TECHNICAL SERVICE BULLETIN

71-C-9

TRIUMPH

Soft Top

Figure 1

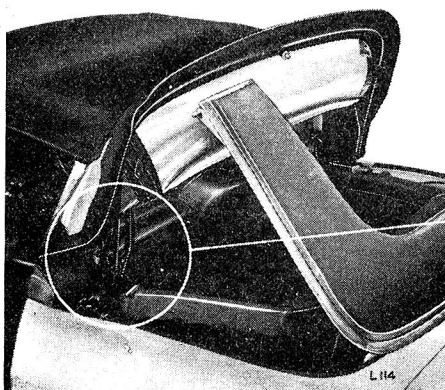
It is important that the retaining hooks on the soft top hood sticks are fully engaged during lowering of the hood assembly (figure 1 and figure 2).

To ensure that full engagement is being achieved, a check is required during pre-delivery and the 1,000 inspection and, wherever necessary, the position of the hooks should be adjusted (arrowed figure 2) by means of the two set screws (not shown) which secure the hook to the hood frame.

There are two hooks, one on either side of the hood frame.
